4oz. 70MM DOUBLE WALL JAR SQUARE

MOLD-RITE PLASTICS INC.
PLATTSBURGH, NEW YORK

SCALE: FULL DATE: 2-17-99 DRAWING NO. J-7016

DRAWING REVISION PAGE

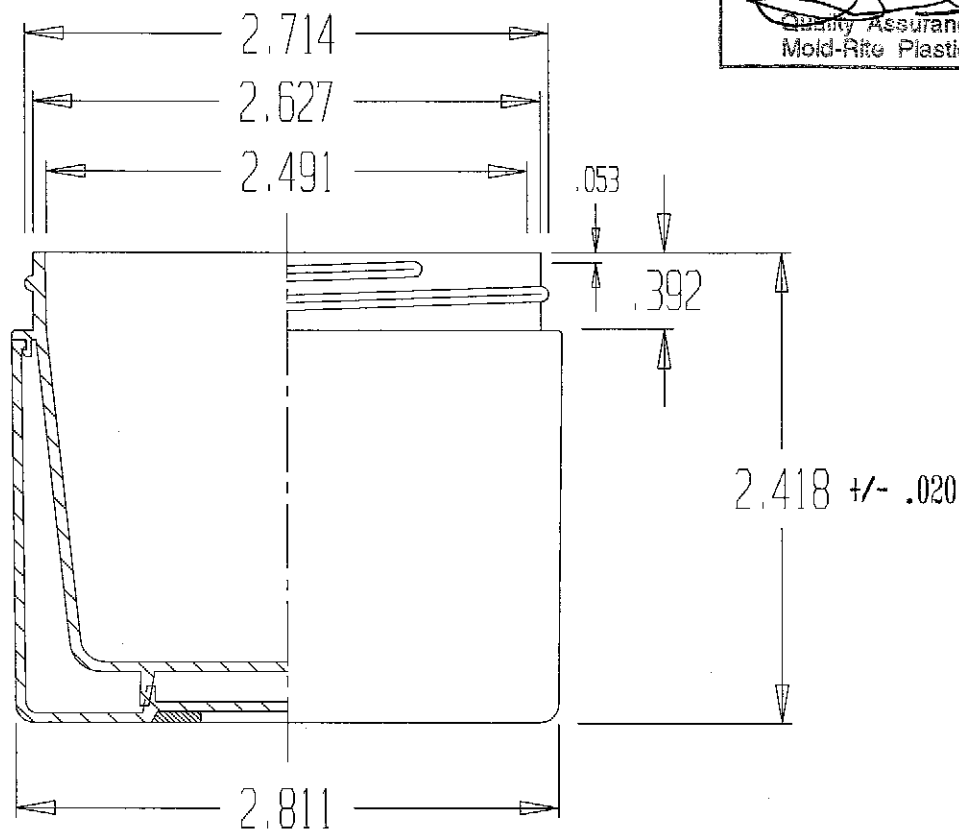
REV LEVEL	REV DATE	DESCRIPTION OF CHANGE
1	Mar. 12, 2004	Drawing required update. Better measuring equipment being used. Changed Overall Height tolerance to +/- .020, added weight tolerance to drawing +/- 1.5 grams. No tooling change.
